BAR Meeting  
May 20, 2009

**ISSUE:** Demolition/Encapsulation

**LOCATION:** 220 South Lee Street

**BAR CASE #2009-0082, 0083 5/20/2009**

PROPOSED WEST ELEVATION

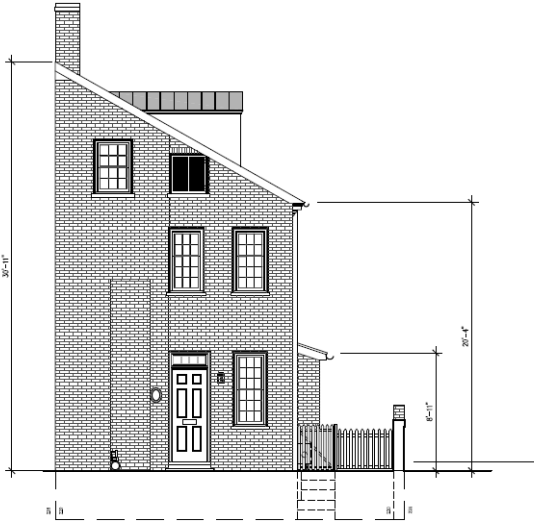
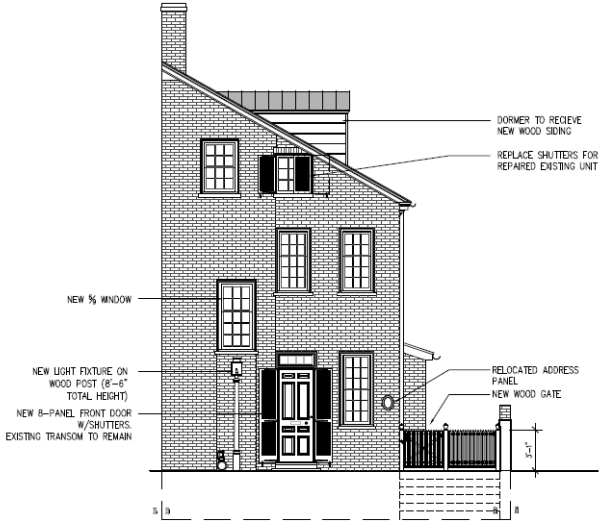
In addition, the west elevation (front elevation) contains a previously filled-in opening between the first and second floors of the house (late 18<sup>th</sup> century façade), the applicants are also proposing to install a new, six over nine pane, wood, single-pane, true-divided light double-hung window in this location. This window re-installation will require approx 17 square feet of demolition.

- R. Approve.  
S. Consider significance of front façade/former masonry opening.

PROPOSED EAST ELEVATION

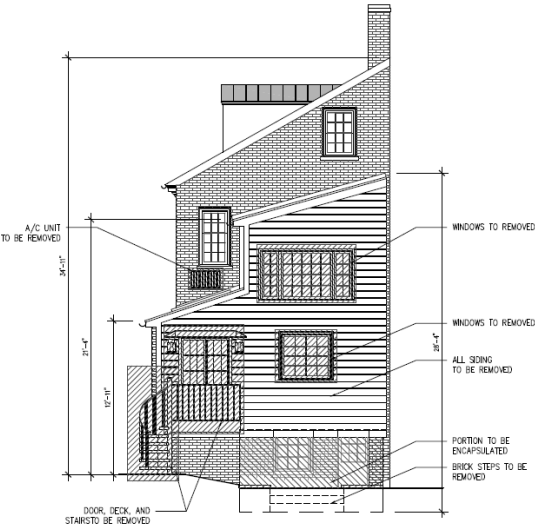
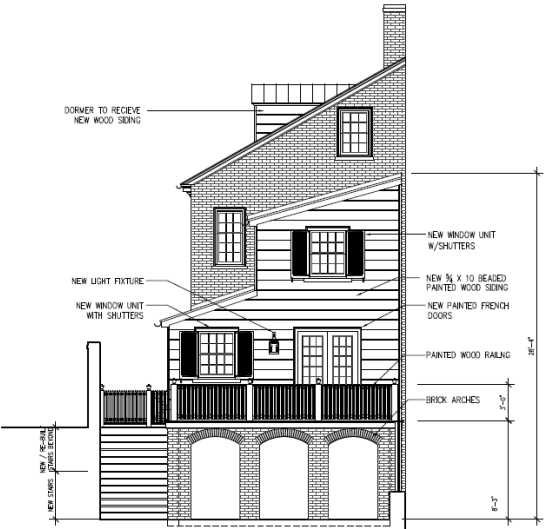
The areas to be encapsulated include: the rear basement wall of the frame extension (east elevation), an area measuring roughly 19 feet in length and 8 feet in height (152 square feet), and the south elevation wall of the frame extension, an area measuring roughly 8.5 feet in length and 8 feet in height (68 square feet).

The modifications to the rear facade are generally modest in scale and will be minimally visible from the public right-of-way (the public alley behind the property is located approximately 22 feet from the proposed porch/deck addition and there will be a grade change of approximately 3 feet 9 inches lower than the current grade within the site making the addition less visible). All of the areas proposed to be encapsulated are on the circa 1980's frame extension. Because the porch/deck addition is at the basement level, the main house and its additions will retain their existing rear walls on the first and second floors.

PROPOSED SOUTH ELEVATION

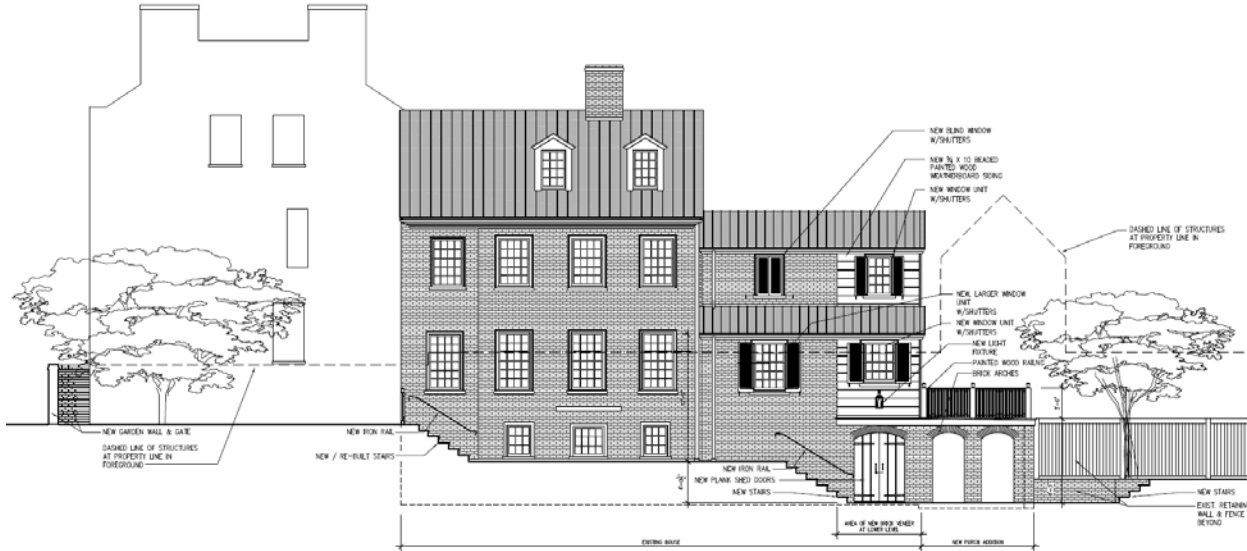
The proposal also includes the re-opening of a formerly closed window and installation of a new blind window with fixed, “closed” shutters on the second floor of the brick addition’s south elevation. This application will require encapsulating 15 square feet of the second floor of the south elevation.

Additionally, most of the areas proposed to be demolished are located on the 1980's frame extension, with exception of two changes to the brick, two-story addition. These changes are confined to the south elevation and include removing an existing window on the first floor to create a larger window opening (on the mid 19<sup>th</sup> century portion of the addition) and installing a false window in the second floor (where there is evidence of a previous window).
